**Pier 40 Structural Restoration – Phase 4
Invitation for Bids (IFB)
Project/Contract #C4874
Addendum No. 1
January 3, 2019**

ATTACHMENT A
SITE LOGISTICS PLAN
(SEPARATE ATTACHMENT)

ATTACHMENT B
AMENDMED AND RESTATED
SPECIFICATION 01140 – WORK RESTRICTIONS
(SEPARATE ATTACHMENT)

AMENDED AND RESTATED SHEET S502 – CONCRETE REPAIR SCHEDULE
(SEPARATE ATTACHMENT)

C4873 and C4874 Logistics Plan

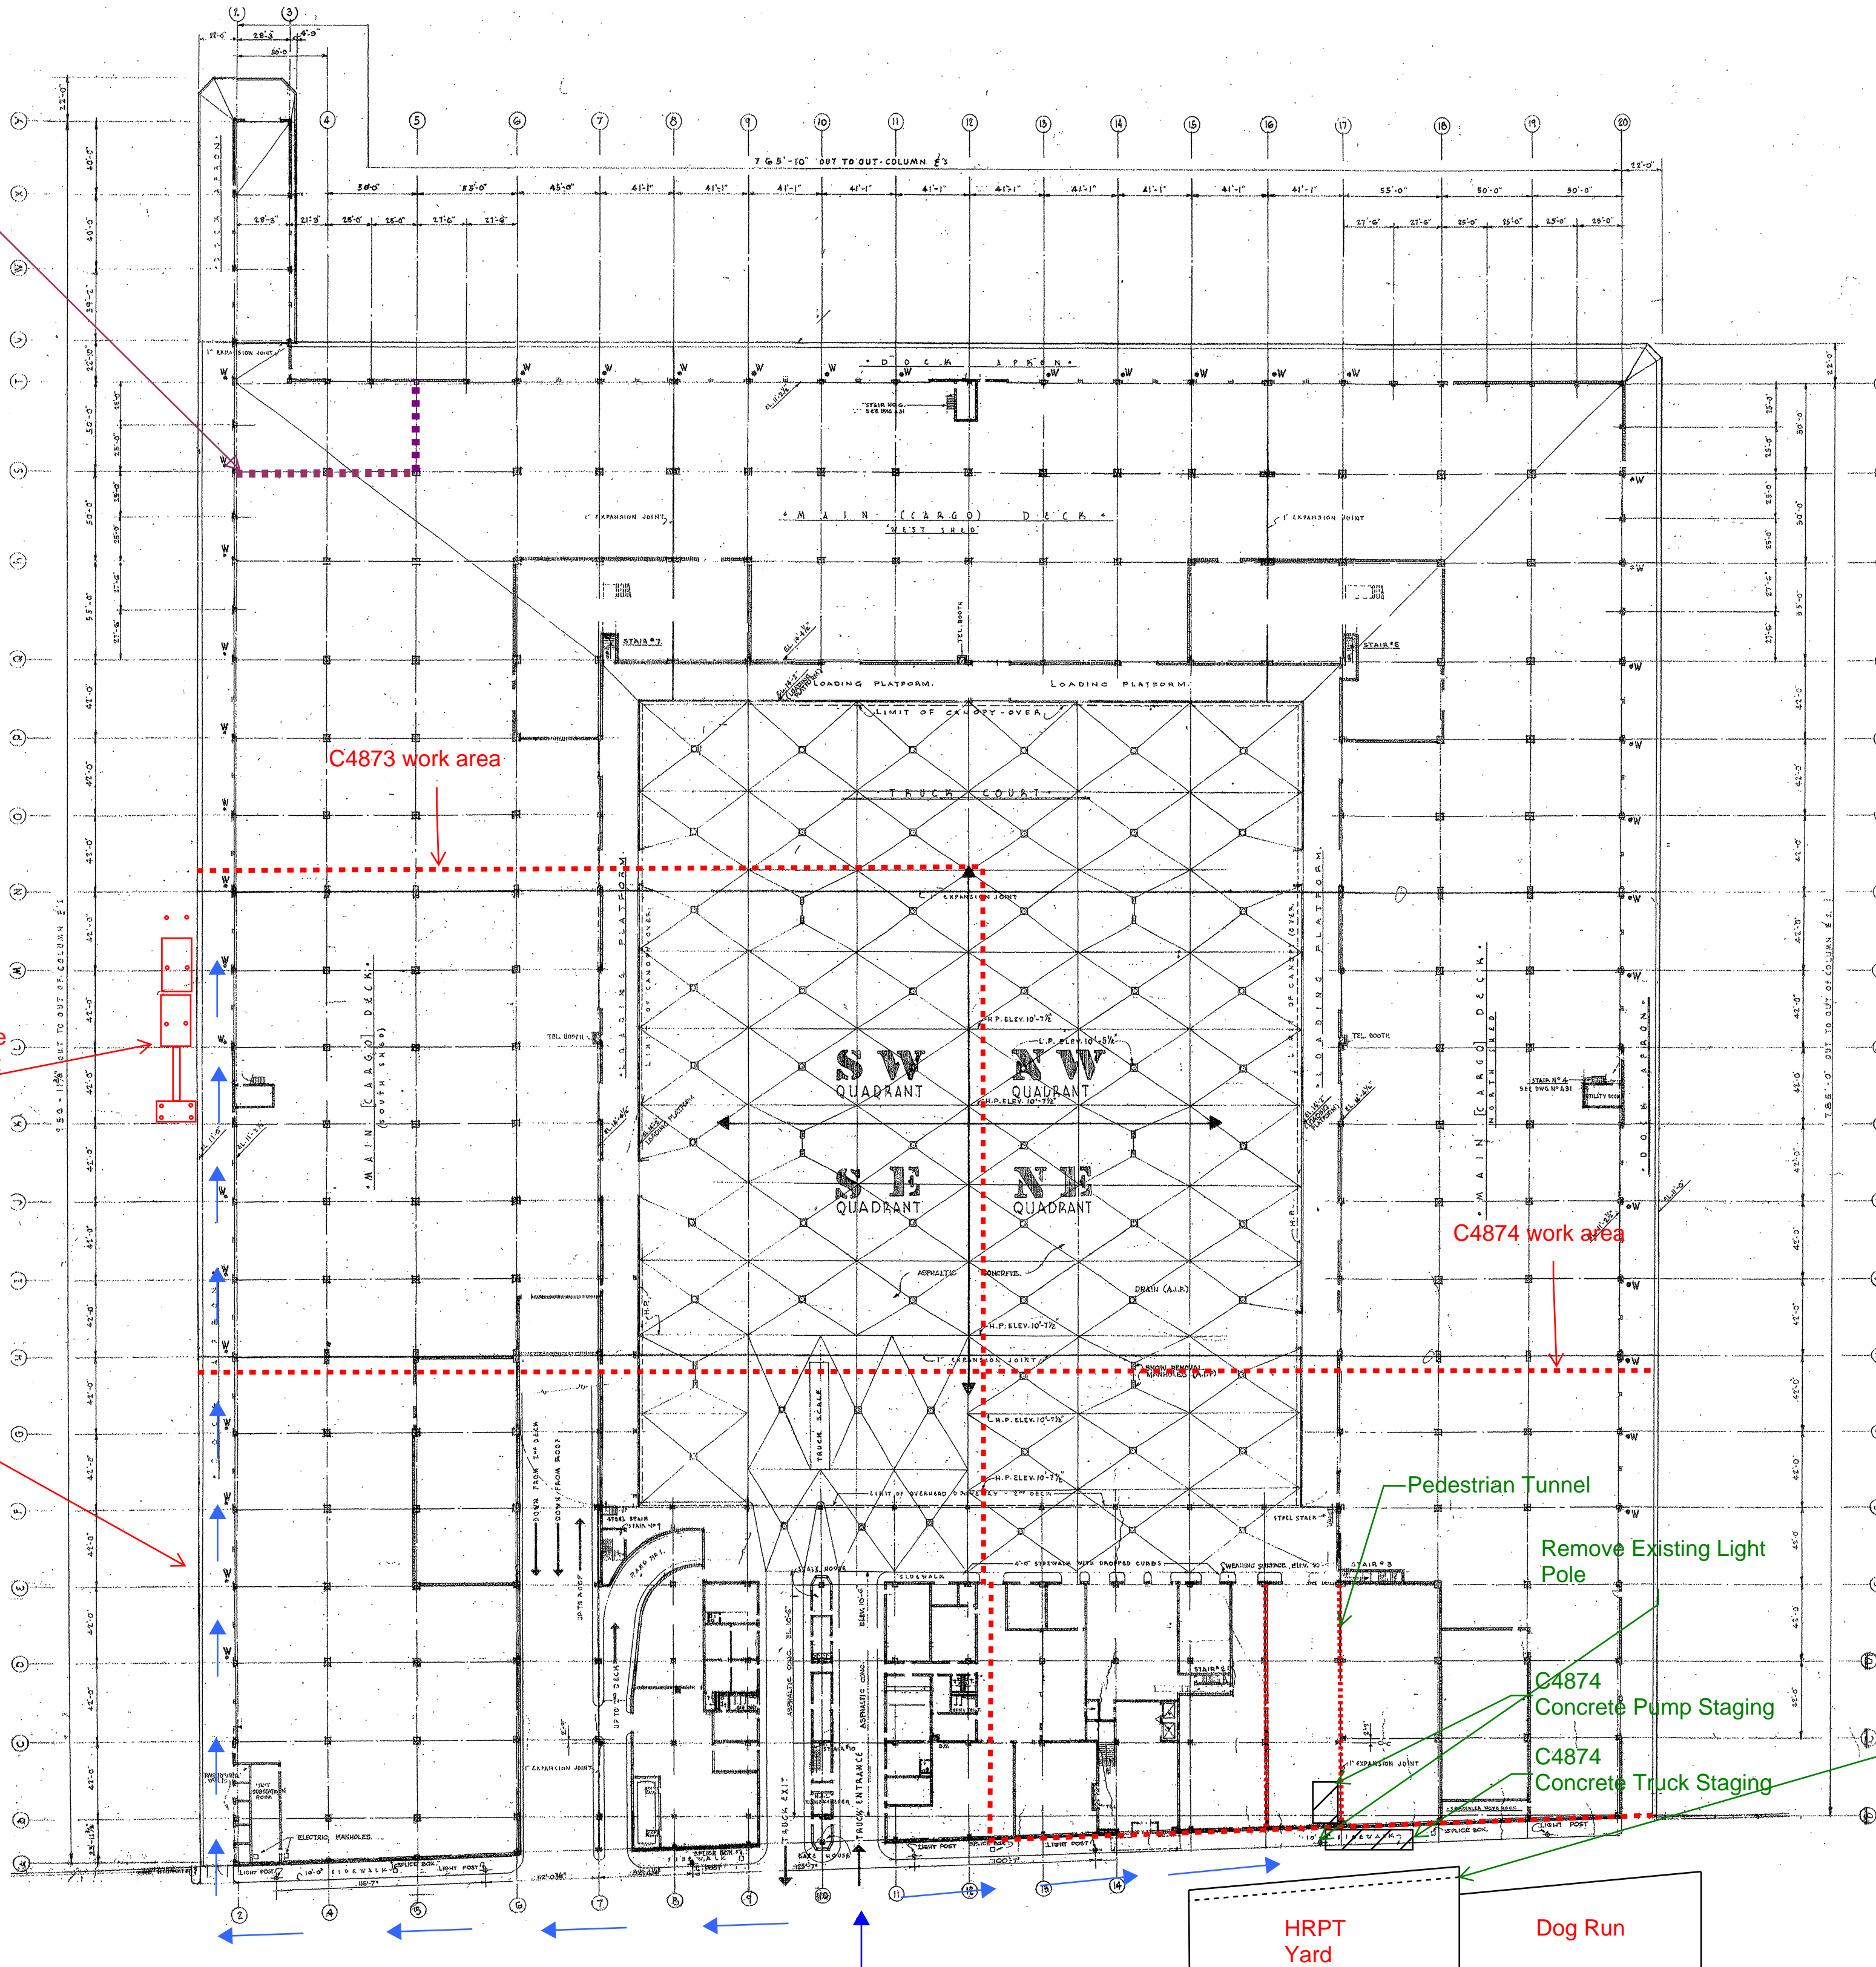
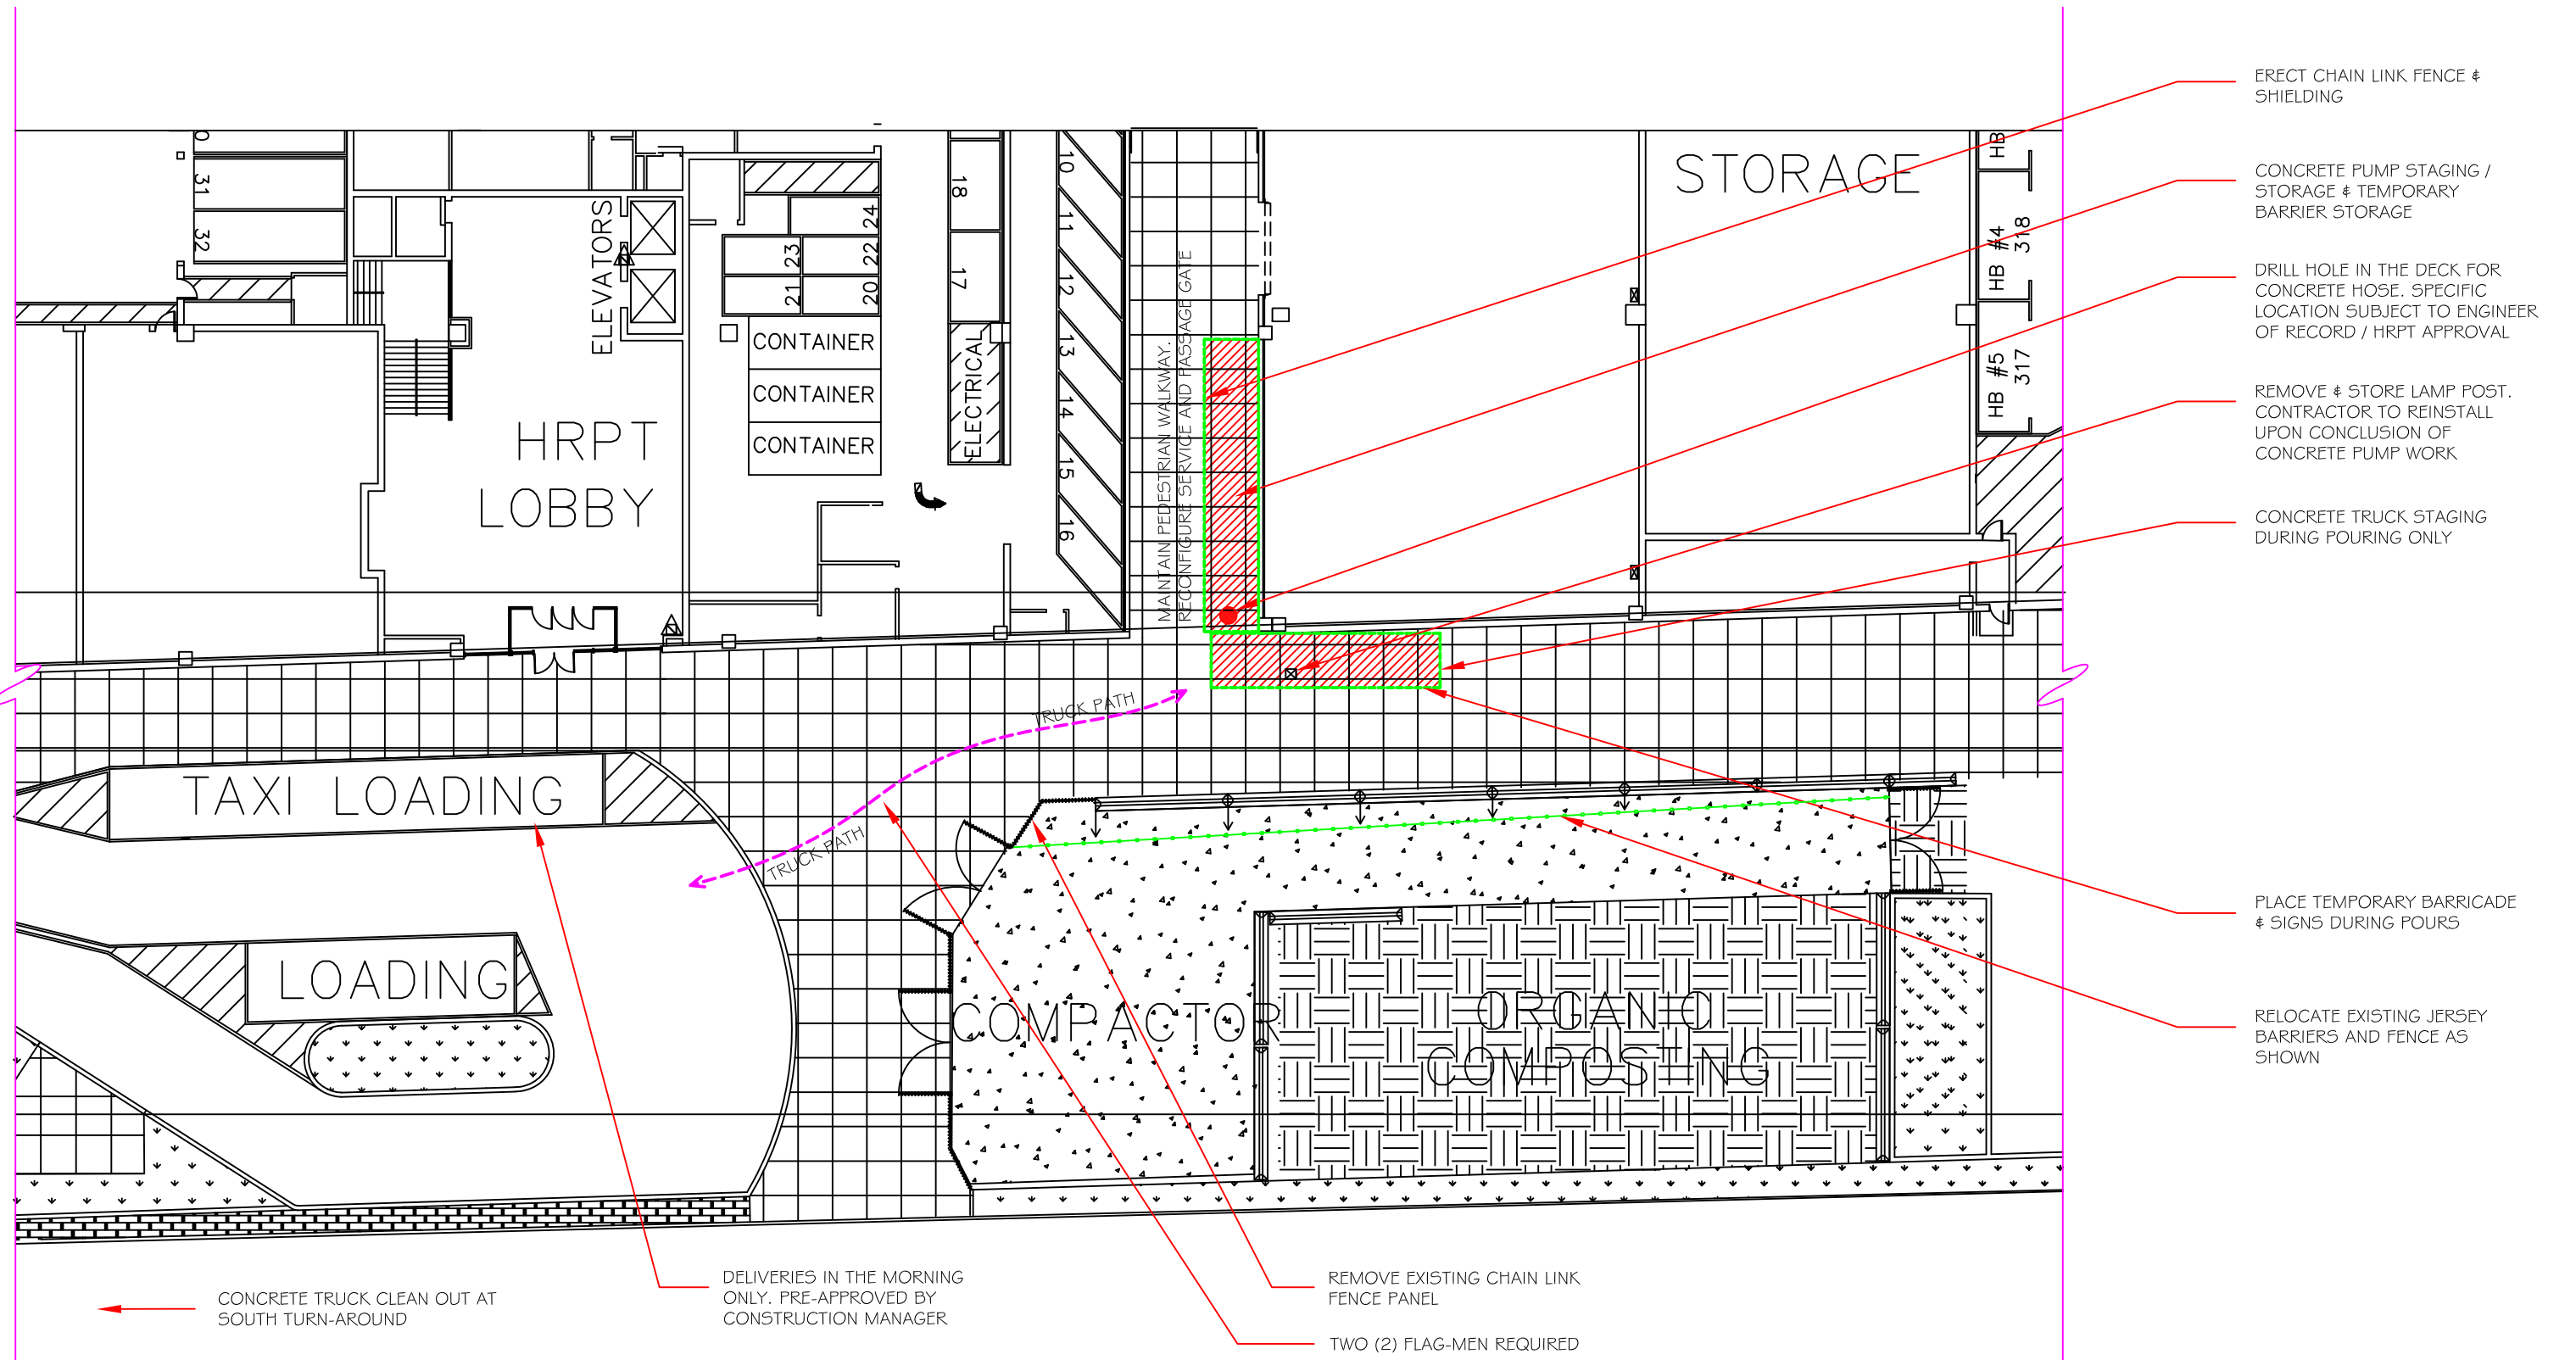
The concrete trucks and other construction vehicles can only travel on the pier and in front of the building when accompanied by two flagmen (front and back)

In the event of temporary closure of any public spaces on the pier, such as during a concrete pour, the contractor is responsible for set up and removal of detour barricades and signs.

North Pier apron will not be available for concrete pour staging (see Work Restrictions section of the project manual).

No dive equipment mobilization the pier aprons will be allowed. All staging is to be located on barges (see Work Restrictions section of the project manual)

C4874 concrete pump shall be set-up inside the pedestrian tunnel. C4874 discharging concrete trucks shall occupy a 11'x35' sidewalk area as shown. Maintain pedestrian access through the tunnel at all times during the concrete pour, inclusive of pedestrian shielding adjacent to the pump.

C4874 contractor will set up and remove temporary barricades and signs for pump and truck staging for each concrete pour day.

C4874 contractor is to relocate the jersey barrier, fence, and one gate approximately 5' east of the current location

C4874 LOGISTICS FRONT OF PIER 40

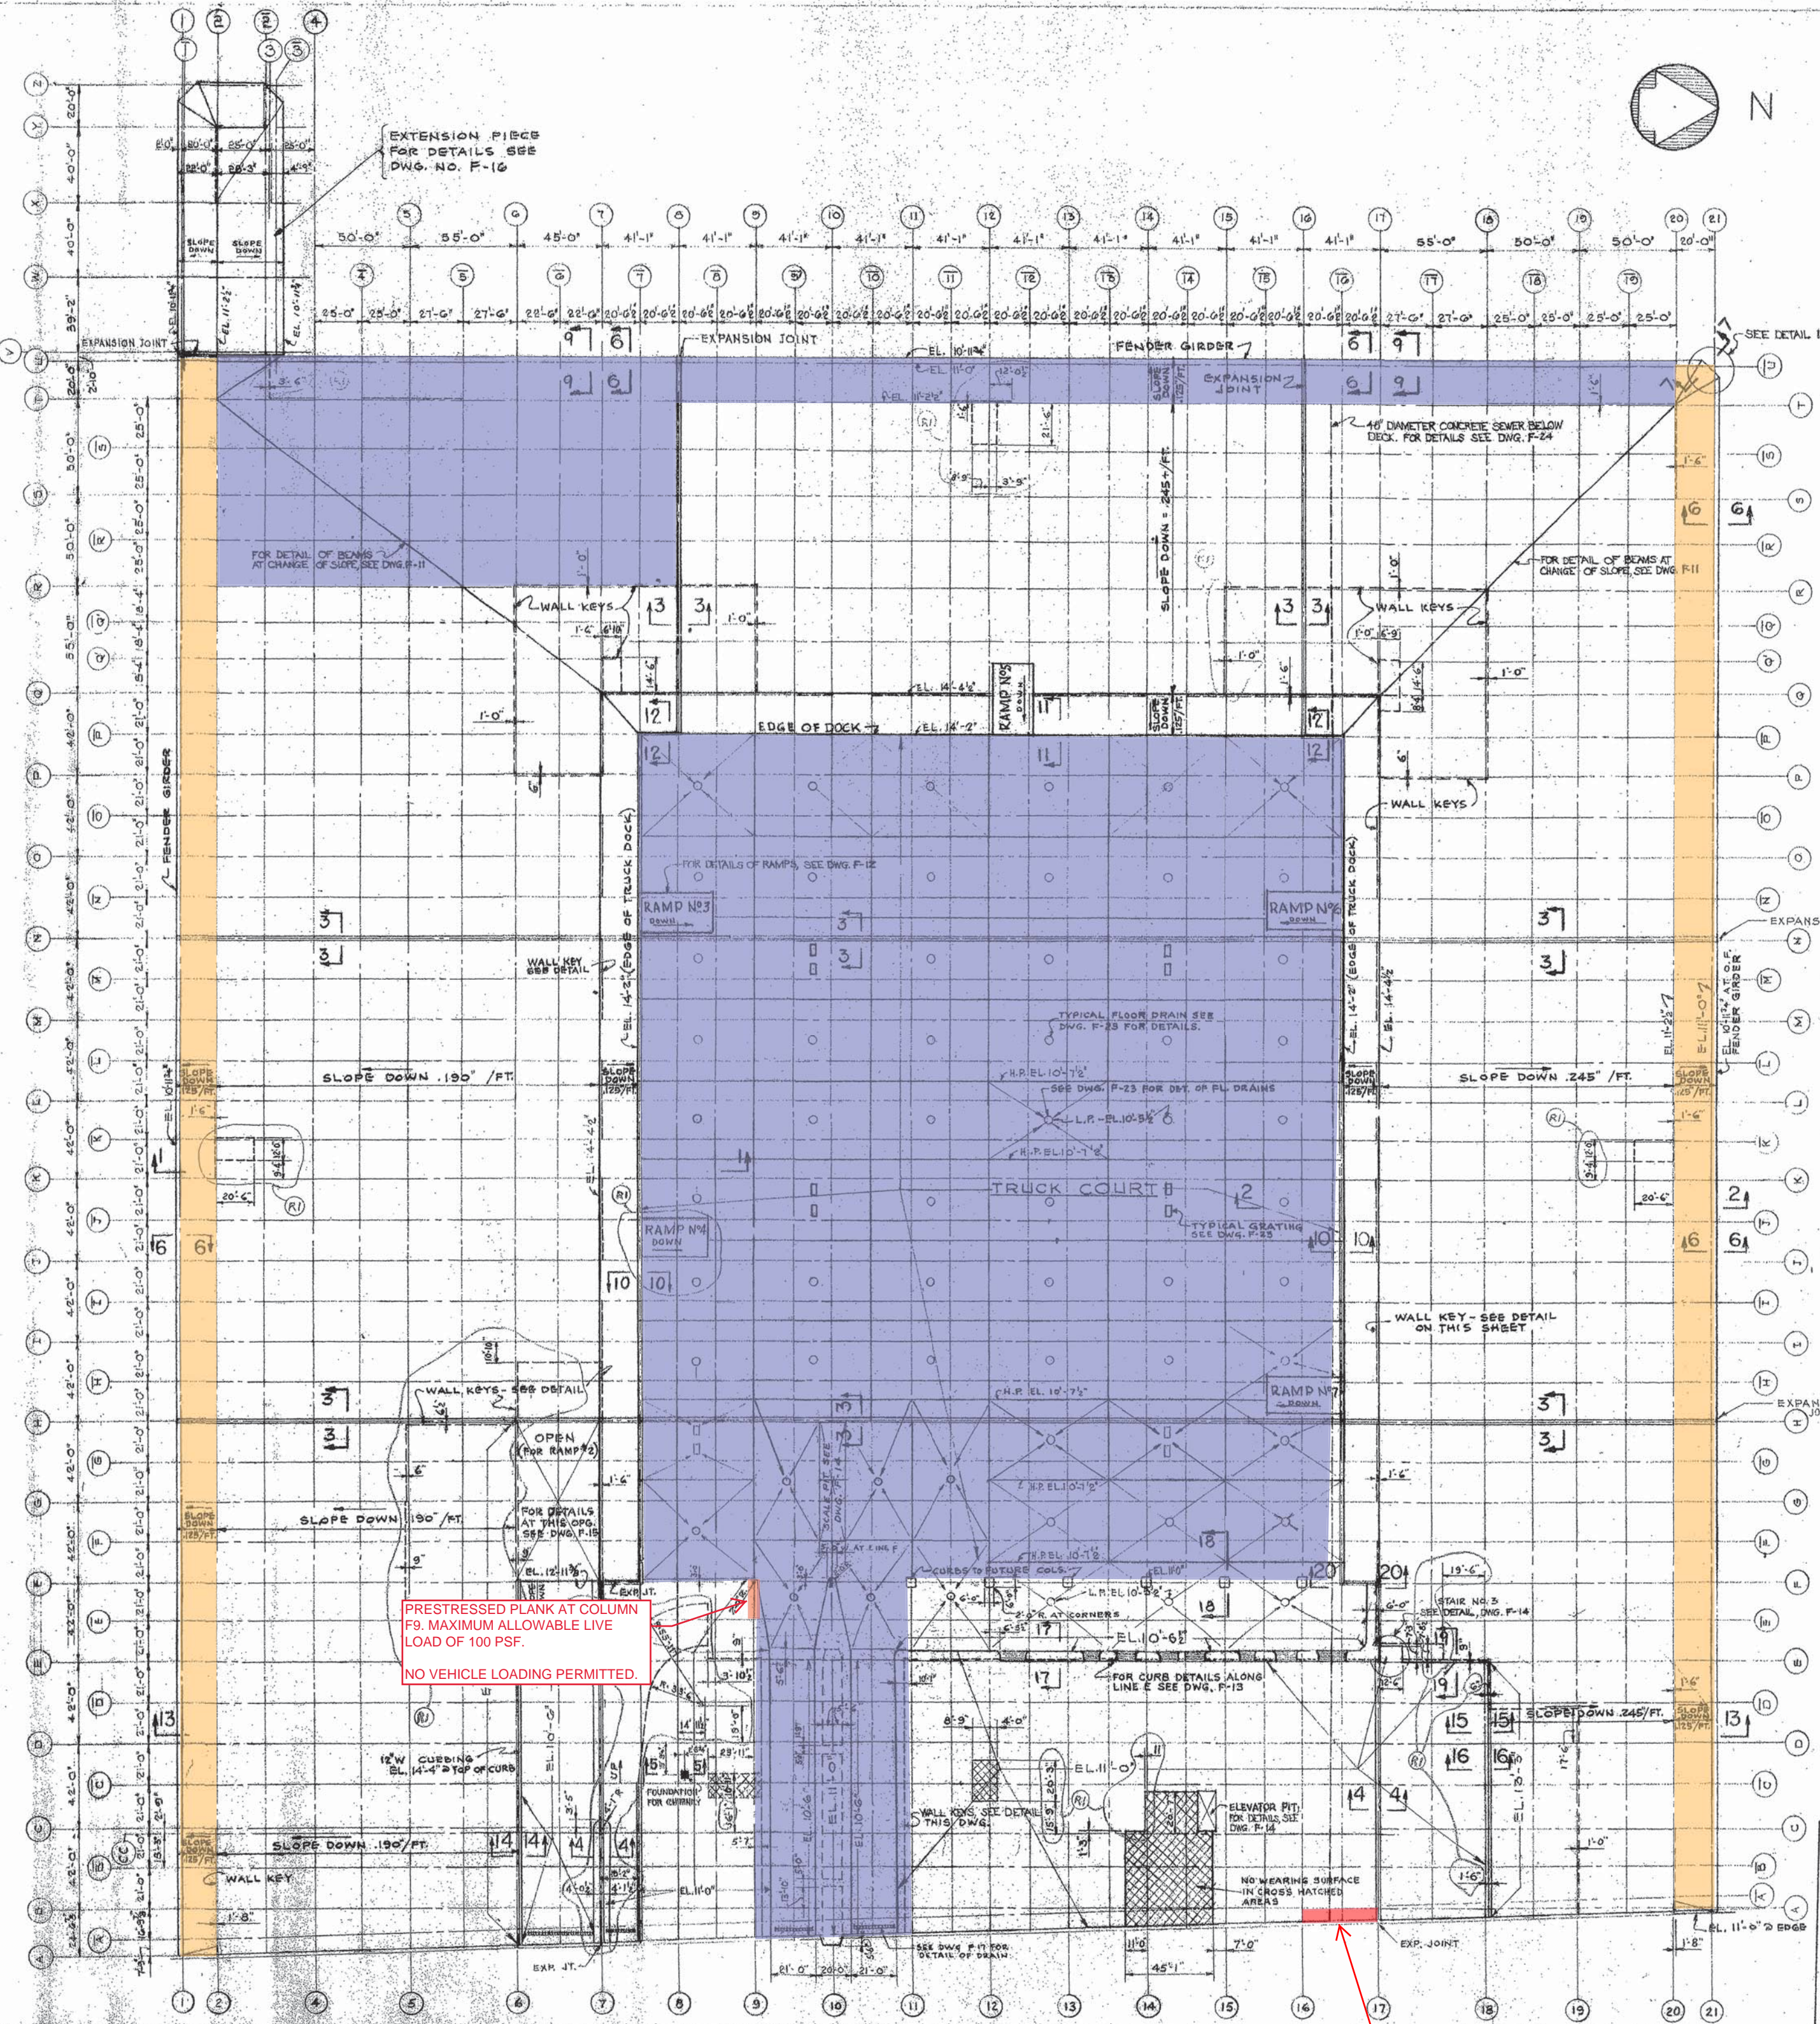
Existing floating docks, ramp, and platform are to be removed by C4873 contractor, guide piles extracted. All salvaged materials relocated and reinstalled in the same configuration appropriately 240' east of the current location. The components to be removed and relocated are as follows:

1. 13.5'x7' timber platform
2. Two 30'x10' wood/plastic docks
3. 25'x3' aluminum ramp
4. Ten (10) 12" diameter (80' long) steel guide piles
